MFN 08-397

Docket No. 52-010

Subject: Response to Portion of NRC Request for Additional Information Letter Nos. 124 and 126 Related to ESBWR Design Certification Application – Design of Structures, Components, Equipment, and Systems - RAI Numbers 3.11-18 and 14.3-218

**Response to Portion of NRC Request for
Additional Information Letter Nos. 124 and 126
Related to ESBWR Design Certification Application
Design of Structures, Components, Equipment, and Systems
RAI Numbers 3.11-18 and 14.3-218**

Figure 3H-2. Control Room Habitability Area Heat up – 0% Exceedance Maximum Temperature Case

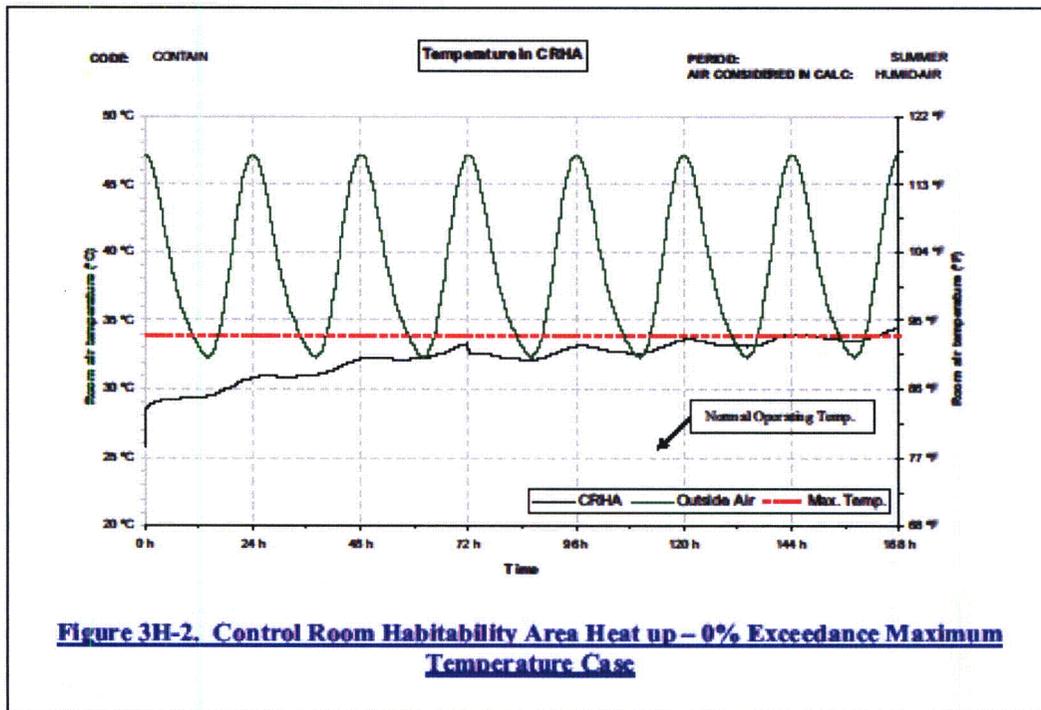
Tables 3H-3, 3H-4, 3H-9, and 3H-10 for the reactor building and control building provide maximum room temperatures for normal and accident conditions used in the establishment of equipment qualification. Please provide an analysis that shows that these temperatures will not be exceeded. The analysis should consider all heat loads affecting the room such as equipment loads, HVAC operation if it is not isolated, heat loads from adjoining rooms, solar loads, personnel loads, lighting, and external environmental conditions for both winter and summer design conditions to the extent they impact room temperatures. If passive measures are used to remove heat loads, please clearly identify these passive measures, the conditions under which they operate, and any surveillance activities that would be required. This analysis should be referenced and summarized in the DCD to support a finding of acceptability.

Detailed thermo-hydraulic heat up analyses were performed with the computer code CONTAIN 2.0 to calculate the room heat up in the Reactor Building and Control Building to show that the equipment qualification temperatures presented in Tables 3H-3, 3H-4, 3H-9, and 3H-10 will not be exceeded. The Reactor Building and Control Building are integrated models so that room-to-room interactions would be considered.

DCD Tier 2, Figure 3H-2 will be added to appendix 3H in revision 5.

The temperature in the CRHA remains below the temperature rise acceptance criteria outlined in Subsection 9.4.1. The 0% exceedance coincident maximum temperature case is presented in Figure 3H-2. Cases were considered to ensure that the 0% exceedance maximum outside air temperature was bounding and 100% relative humidity with additional moisture created by CRHA occupants (latent load) would not lead to a 72 hour CRHA air temperature higher than the 0% exceedance coincident maximum temperature case, and ensure the heat absorbed by the CRHA structures would not be adversely impacted by the condensation created. The results of this analysis show that higher humidity ratios, and subsequently higher specific enthalpy, do not affect the maximum temperature reached with little condensation occurring on the walls of the control room. The concrete heat sink provides enough thermal mass to keep the CRHA within limits during the limiting event by absorbing heat loads or heating ambient air during summer or winter conditions.
